SUBJECT: OCONEE NUCLEAR STATION, UNITS 1, 2 AND 3 RE: ISSUANCE OF AMENDMENTS - PRESSURE-TEMPERATURE OPERATING CURVES (TAC NOS. MA5459, MA5460, AND MA5461)

The Nuclear Regulatory Commission has issued the enclosed Amendment Nos. 307, 307, and 307 to Facility Operating Licenses DPR-38, DPR-47, and DPR-55, respectively, for the Oconee Nuclear Station, Units 1, 2, and 3. The amendments consist of changes to the Technical Specifications (TS) in response to your application dated May 11, 1999, which was supplemented by letter dated July 13, 1999.

The amendments incorporate revisions to the pressure-temperature limits; the heatup, cooldown, and inservice test limits for the reactor coolant system to a maximum of 33 effective Full Power Years; the low temperature overpressure protection system; and operational requirements for the reactor coolant pumps.

ATTACHMENT TO LICENSE AMENDMENT NO. 307

Figure 3.4.3-1 (page 1 of 1)
RCS Normal Operational Heatup Limitations
Applicable for the First 33 EFPY - Oconee Nuclear Station Unit 1

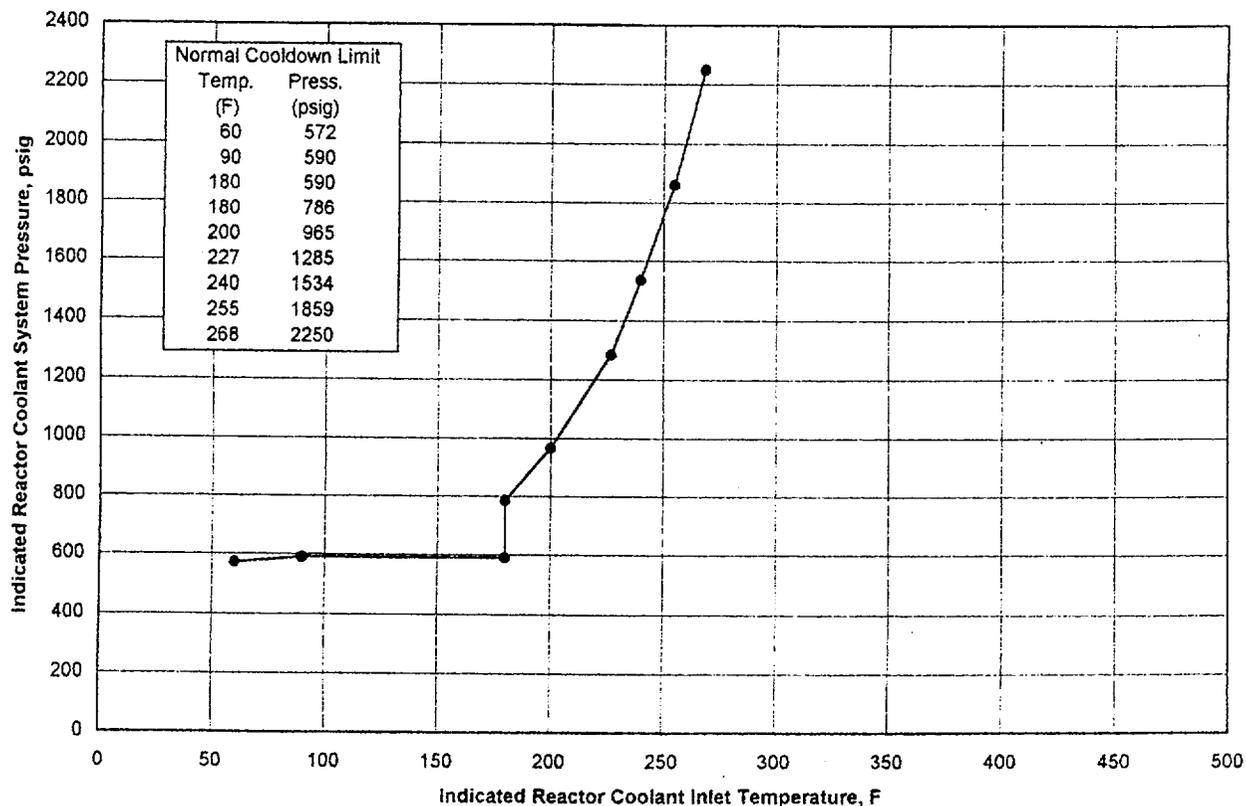
A proposed change would extend the current P/T curves (Figures 3.4.3-1 through 3.4.3-9) to 33 EFPY, which is beyond the current Oconee license limit of 26 EFPY. A proposed change to TS 3.4.12, Low Temperature Overpressure Protection, would increase the power operated relief valve (PORV) setpoint from 460 pounds per square inch gage (psig) to 535 psig. The LTOP pressures, temperatures, and setpoints developed in this application are the same for all three units.

The staff has reviewed the proposed LTOP changes to TS 3.4.3 and the associated bases and determined that the proposed revisions satisfy the Appendix G (to 10 CFR Part 50) requirements as modified by the ASME Code Cases N-514, N-588 and N-626, for which exemption requests have been approved. The proposed modification extends the period of the LTOP applicability to 33 EFPY. These changes are acceptable.
